## Notes for Permissive path management scheme

### Greenhill documents: GH7.10; APP-554.

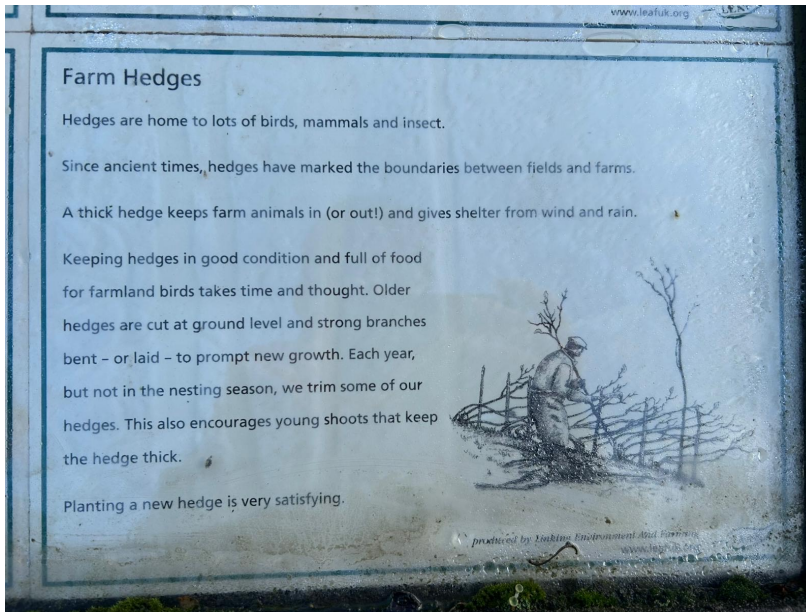
- 13.** In various submissions the developer has pointed out that walkers will not see the solar panels because hedge planting will screen them from view. This will take some 15 years for the hedges to reach around 4.5 metres. Two points can be made about this: First, that 15 years is not a short duration for the impact of these new routes to be felt. Second, hedges require to be trimmed each year if their health is to be maintained. The documentation on hedges displayed at Castle Ashby refers to the need for annual cutting:

It is noticeable that each winter the hedges around local fields are indeed cut – to a height of perhaps 2 metres. This will mean that, to reach 4.5 metres, hedges will need to be little tended and allowed to grow higher, not only obscuring the views, but also being out of line with other hedges that have been pruned. The character of the landscape is therefore significantly altered for the lifetime of the scheme.
